PIC18F85J90 Family Data Sheet Errata

Clarifications/Corrections to the Data Sheet:

In the Device Data Sheet (DS39770B), the following clarifications and corrections should be noted. Any silicon issues related to the PIC18F85J90 family of devices will be reported in a separate silicon errata. Please check the Microchip web site for any existing issues.

FIGURE 16-10: I²C™ SLAVE MODE TIMING (TRANSMISSION, 7-BIT ADDRESS)

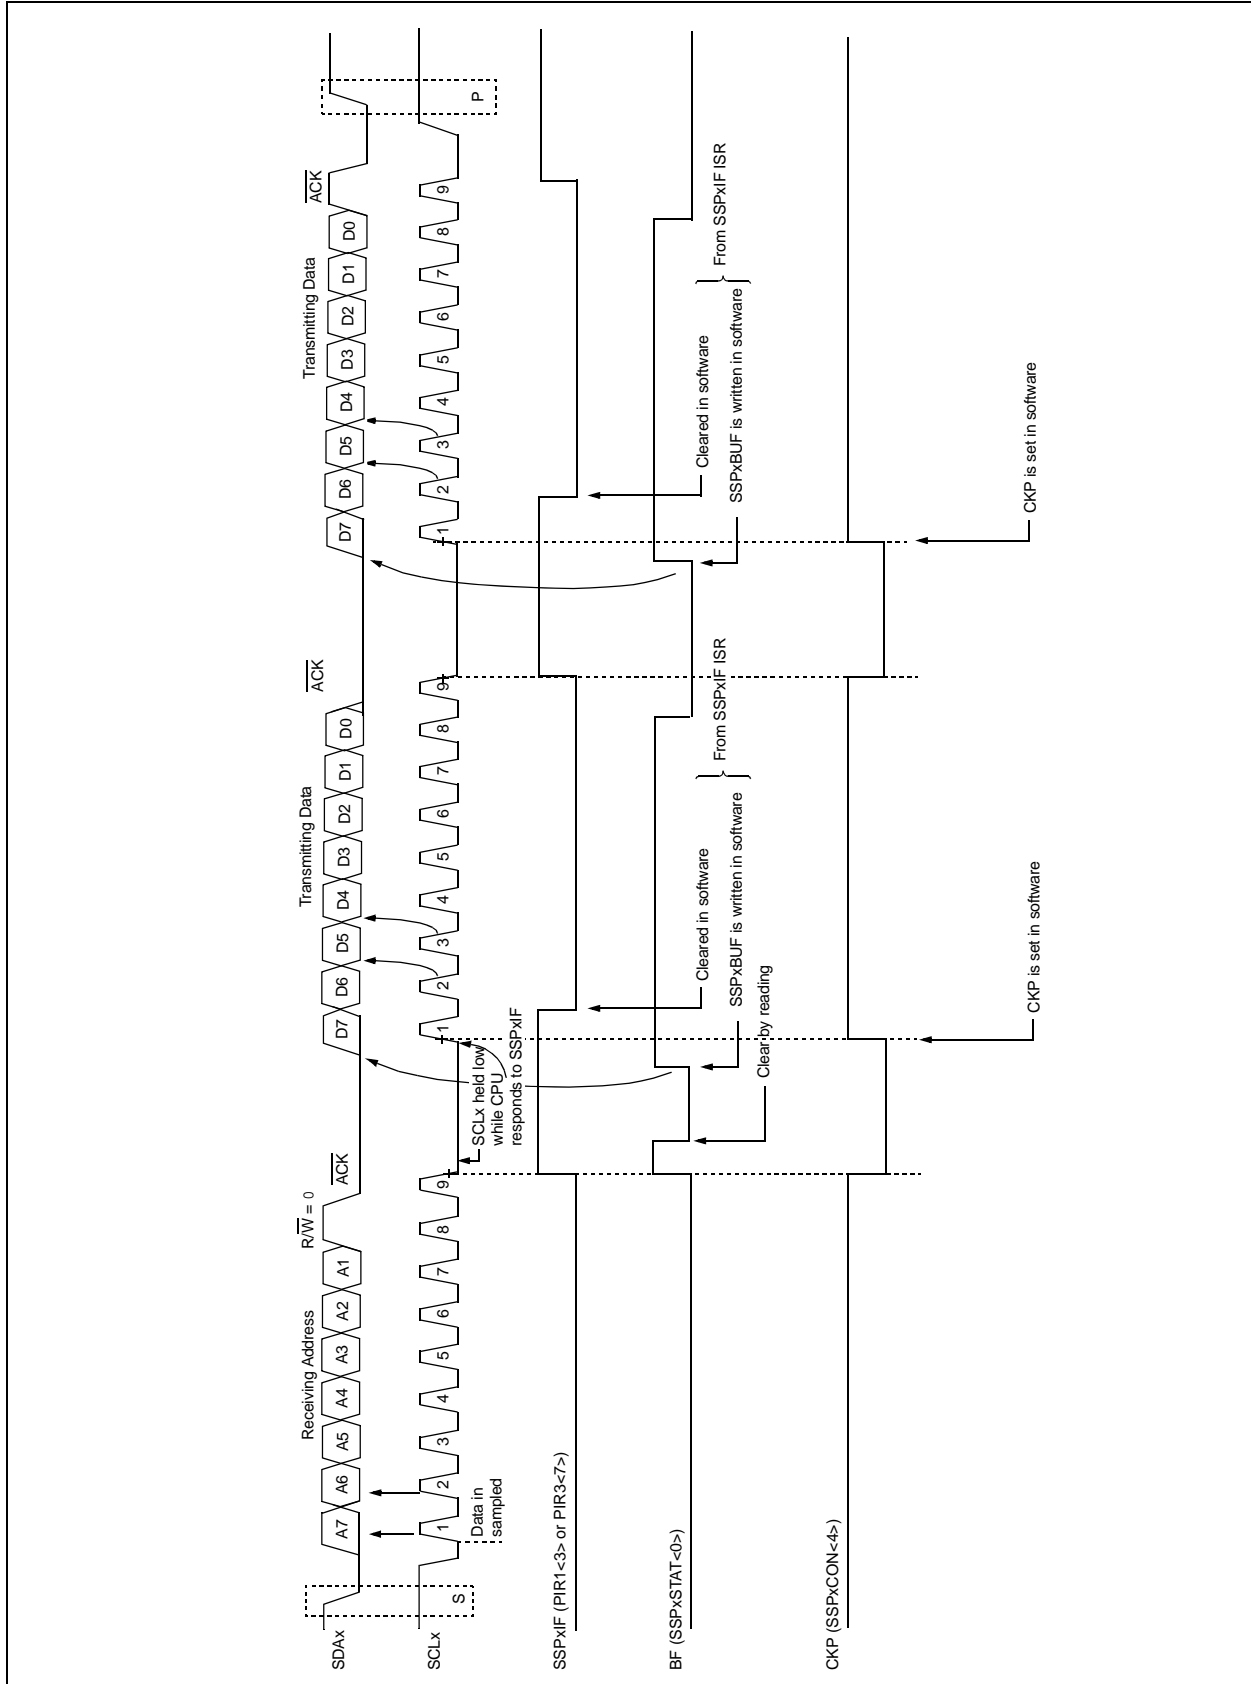
21. Module: Figure 16-10: I²C™ Slave Mode Timing (Transmission, 7-Bit Address)

On page 204, the figure is replaced with the new timing diagram provided in Figure 16-10.

FIGURE 16-24: I²C™ MASTER MODE WAVEFORM (RECEPTION, 7-BIT ADDRESS)

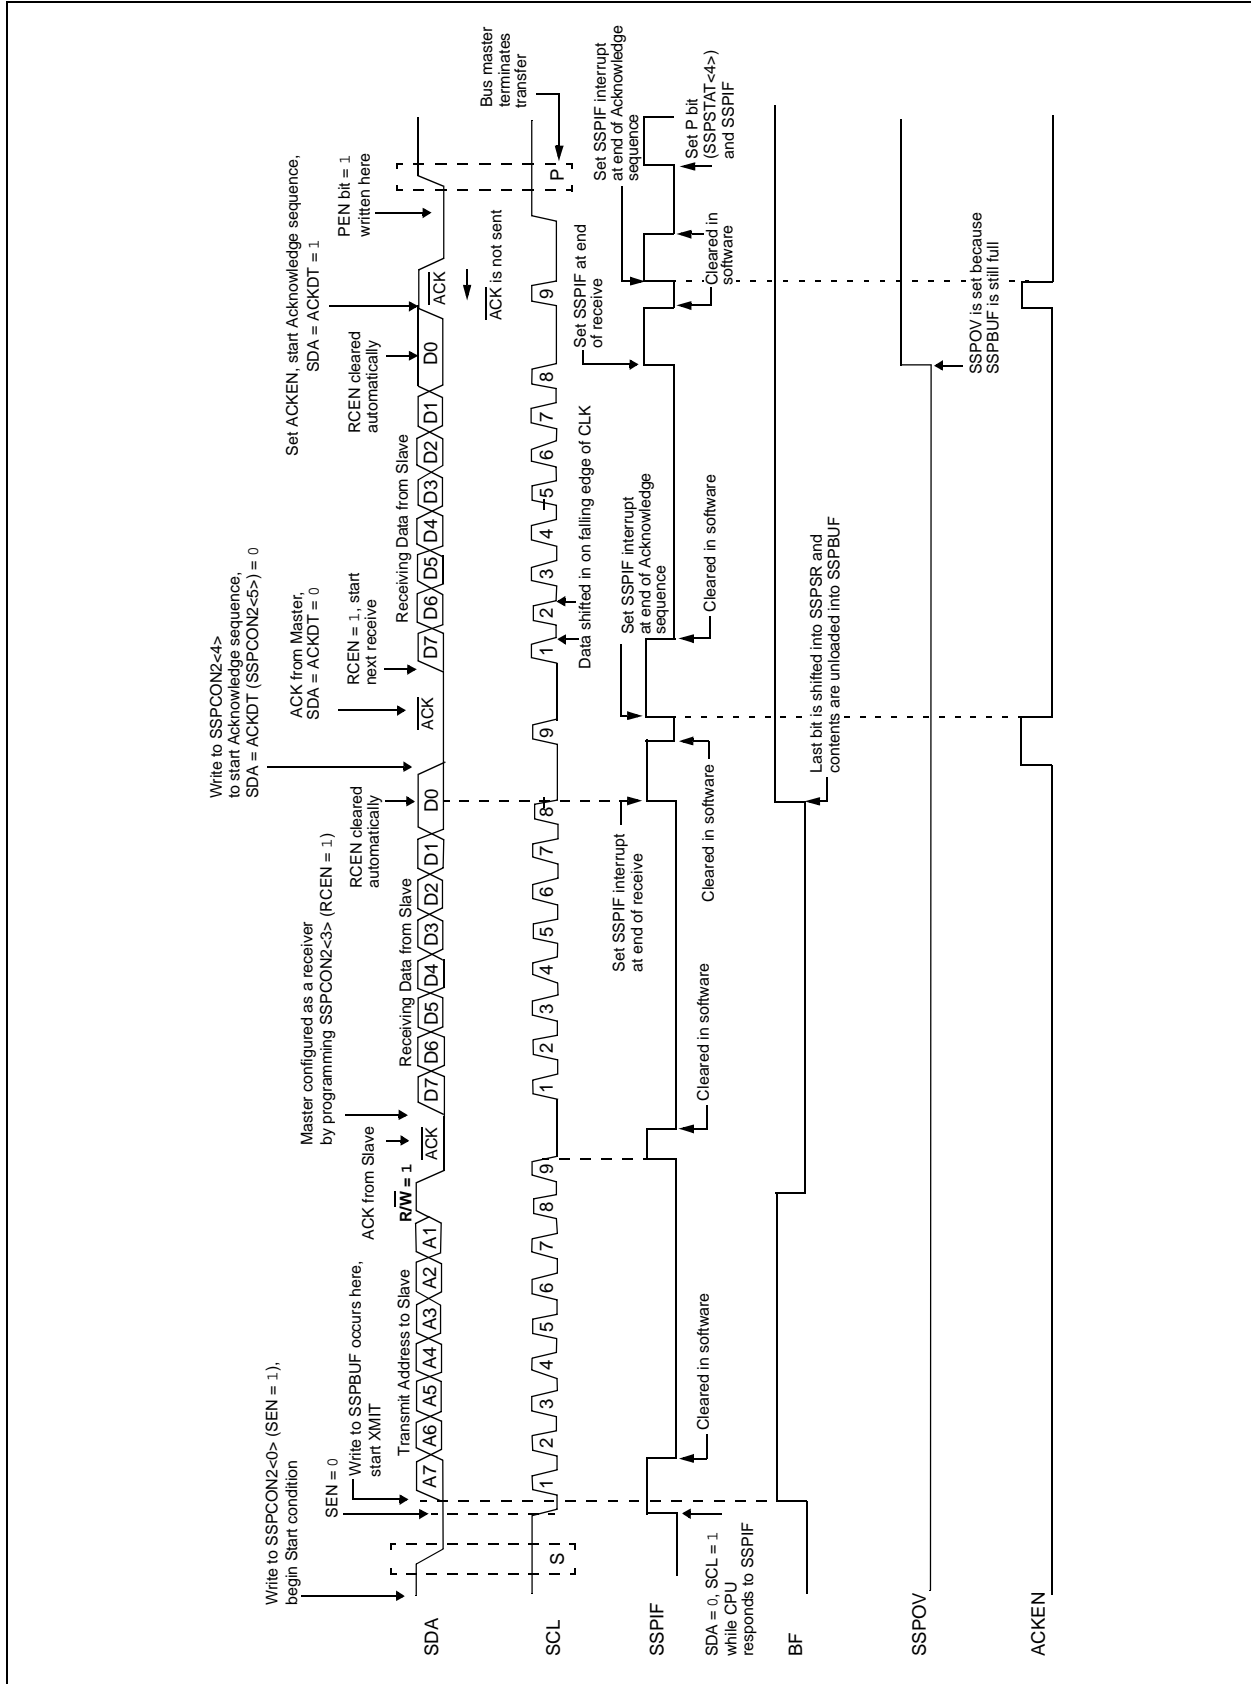
22. Module: Figure 16-24: I²C™ Master Mode Waveform (Reception, 7-Bit Address)

On page 221, the condition (R/\overline{W}) when the Acknowledge signal (ACK) is received from the slave, after transmitting the address to the slave, is changed to '1'. The changed value is indicated in bold text in Figure 16-24.
